Product Improvement Campaign

No: C1005510

Re: DUONIC Transmissions Below ZF31446

Customer Confidence Program C1005510 - DUONIC Transmissions Below Serial # ZF31446

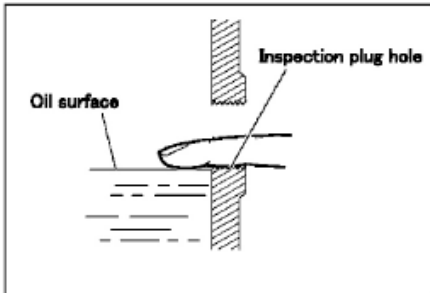
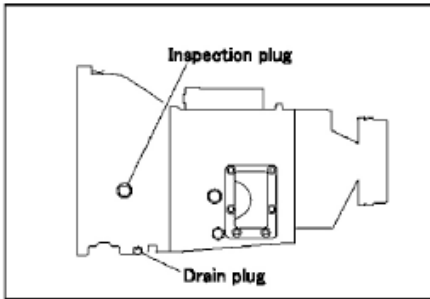
The DUONIC transmission serial number and ATF level in the front reservoir must first be inspected. If the serial number is below ZF31446, follow the instructions in this bulletin to replace transmission assembly. The transmission assembly will be replaced to prevent front seal leaks and/or excessive gear noise. If the serial number is above ZF31446, follow the instructions in bulletin C1005320.

1. Park the vehicle on a flat, level surface, turn off the engine, apply the parking brake and chock the wheels.  
**CAUTION! Do not remove the wheel chocks until all modification work has been completed.**
2. Inspect the DUONIC transmission serial # and confirm that it is **ZF31446** or lower.
3. Check the ATF level using the following procedure:
  - Start the engine and raise the transmission fluid temperature to approximately 120°F (50°C) [using FUSO Diagnostics to monitor the transmission fluid temperature].
  - Perform the following procedure to fill the hydraulic circuit with ATF.

Remove the inspection plug and check the ATF level to determine if the fluid is filled to the bottom of the plug hole.

- If the ATF level is lower than the bottom of the hole, fill the reservoir with 200cc of new DUONIC SP III ATF using the supplied, graduated bottle. Stop filling if ATF flows from the inspection hole and record the level at **Correct**. If the reservoir holds the entire 200cc of ATF without it flowing from the hole, record the fluid level as **Low**. Note: Accurate ATF level reporting is essential to the core handling process.

- Reinstall the inspection plug and gasket and tighten to 60 ft.lbs. (81 Nm).
